APPLICANT(S) Joseph Louis Petrucci, Jr. **GROUP ART**
UNIT:Unknown
APPLN. NO.: EXAMINER: Unknown
FILED: Concurrently Herewith
TITLE: METHOD AND SYSTEM FOR DETERMINING A
PERFORMANCE OF PLASMA ETCH EQUIPMENT

PRELIMINARY AMENDMENT

FIG. 1

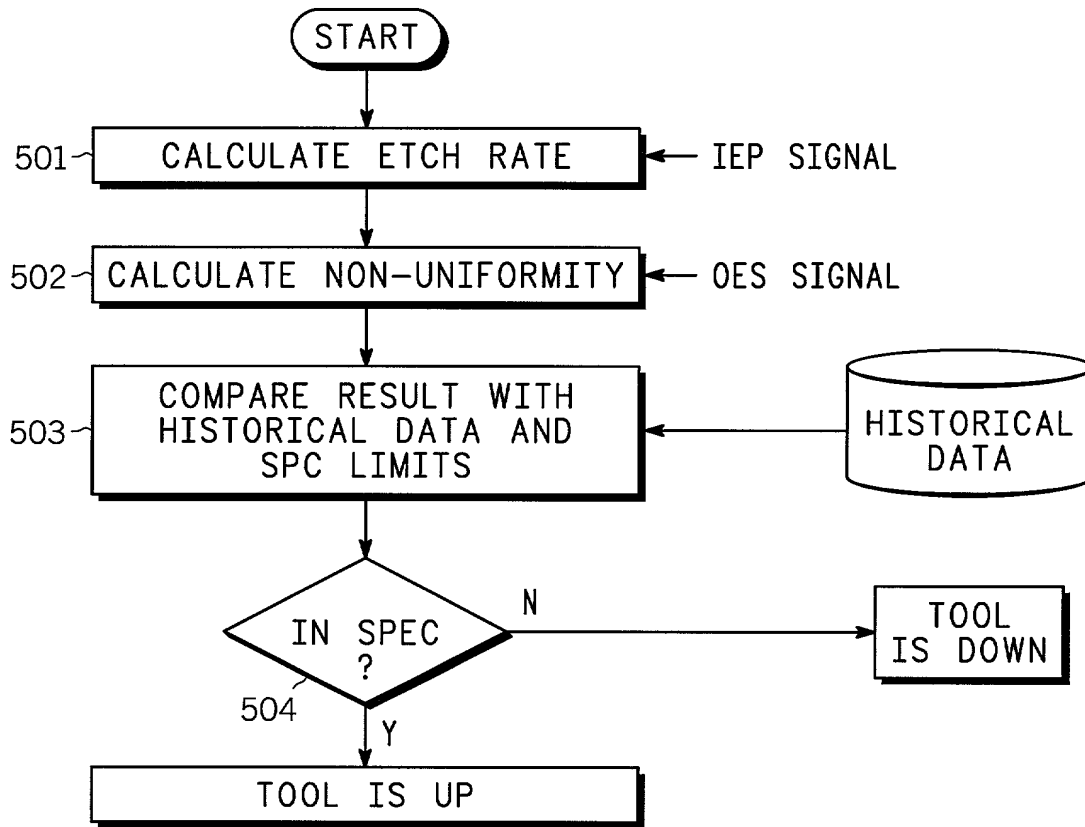
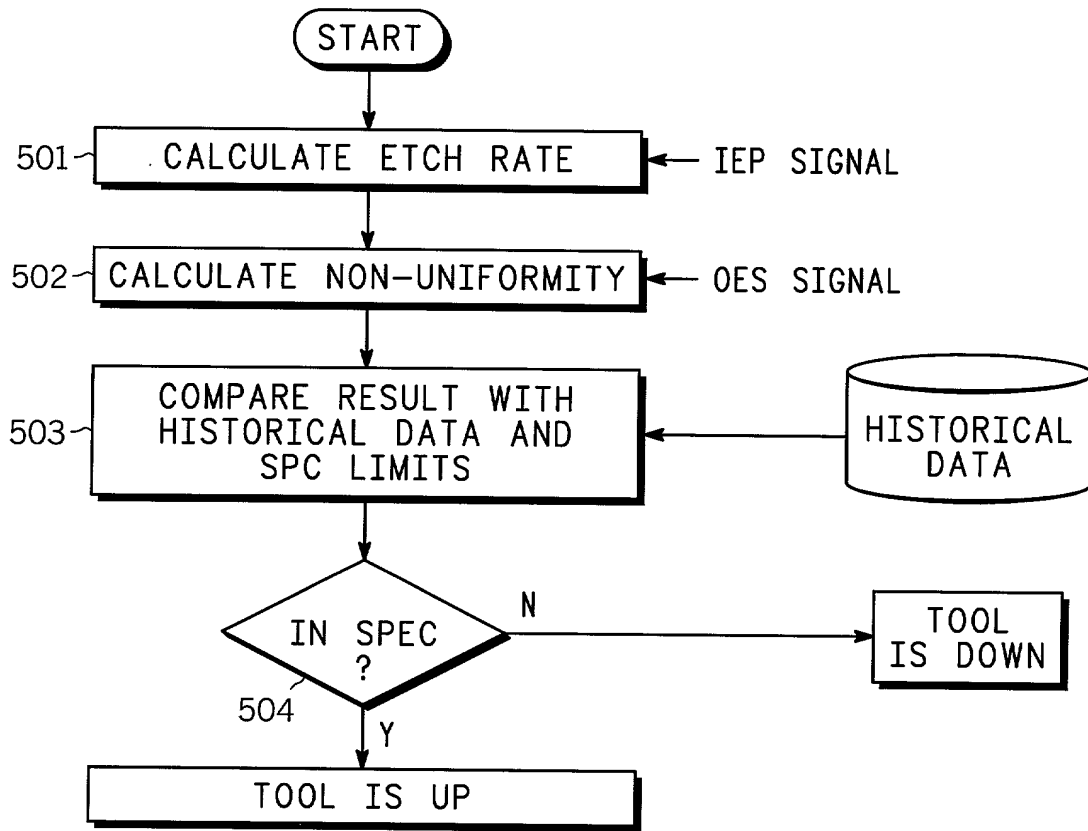
The amendments to the specification are made so that the specification is consistent with FIG. 1. The amendment to FIG. 2 is made to correct a typographical error in the label of block 14.

After starting the process, in step [S01] 501 an etch rate is calculated. The etch rate is calculated, for example, by analyzing an IEP signal which will be described further below with reference to Figure 3. The etch rate can also be calculated on the basis of an OES signal. Such analysis will be described further below with reference to Figure 4.

After calculating the etch rate, in step [S02] 502 the non-uniformity of a film to be etched is calculated. The calculation of the non-uniformity is performed on the basis of an OES signal which will be described with reference to Figure 4 further below.

After calculating the non-uniformity, in step [S03] 503 the results of etch rate calculation and non-uniformity calculation are compared with historical data and/or statistical process control (SPC) limits.

In step [S04] 504 it is decided, whether the calculated etch rate and the calculated non-uniformity are within a specification, on the basis of the step of comparing ([S03] 503). If the results are within the specification it is decided that the plasma etch tool is up, and normally no measures have to be taken. If both or one of the calculated values is not in the specification, it is decided that the tool is down. In this case, for example, the tool can be removed from the production line.

- - After starting the process, in step 501 an etch rate is calculated. The etch rate is calculated, for example, by analyzing an IEP signal which will be described further below with reference to Figure 3. The etch rate can also be calculated on the basis of an OES signal. Such analysis will be described further below with reference to Figure 4.- -

- - After calculating the etch rate, in step 502 the non-uniformity of a film to be etched is calculated. The calculation of the non-uniformity is performed on the basis of an OES signal which will be described with reference to Figure 4 further below.- -

- - After calculating the non-uniformity, in step 503 the results of etch rate calculation and non-uniformity calculation are compared with historical data and/or statistical process control (SPC) limits.- -

- - In step 504 it is decided, whether the calculated etch rate and the calculated non-uniformity are within a specification, on the basis of the step of comparing (503). If the results are within the specification it is decided that the plasma etch tool is up, and normally no measures have to be taken. If both or one of the calculated values is not in the specification, it is decided that the tool is down. In this case, for example, the tool can be removed from the production line.- -

FIG. 2

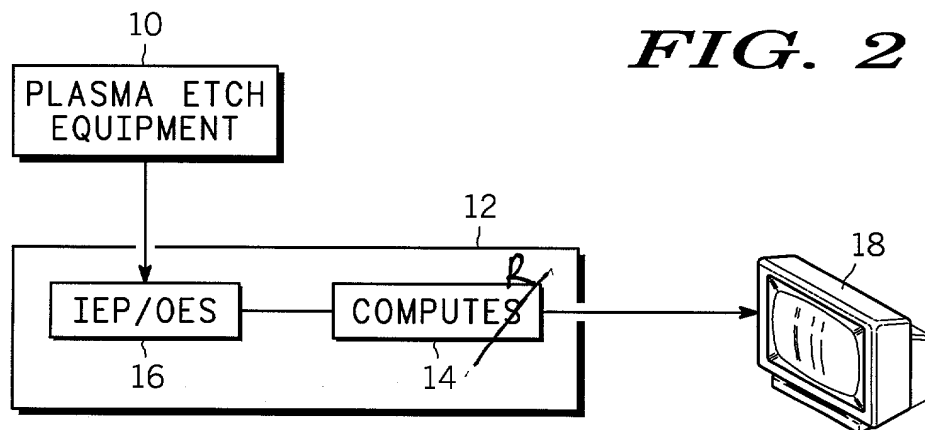
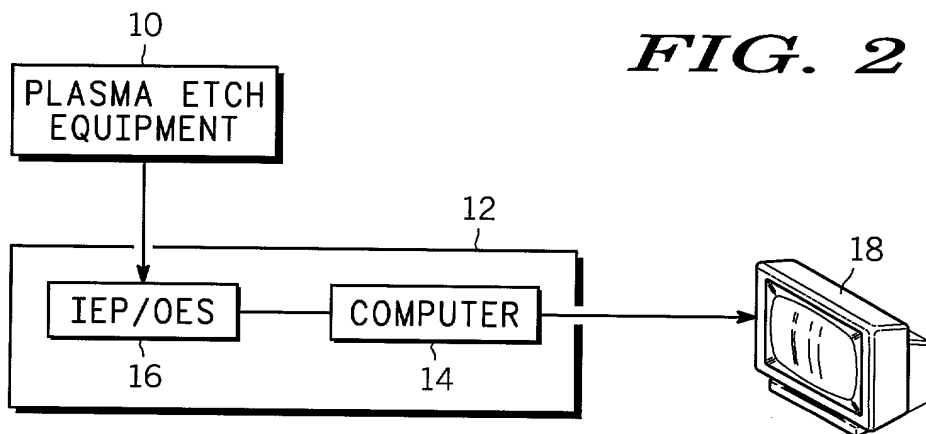
In FIG. 2 of the drawings, block 14 original read "COMPUTES", but is corrected to read - -COMPUTER- -as noted on the red-lined drawing of sheet 1/2.
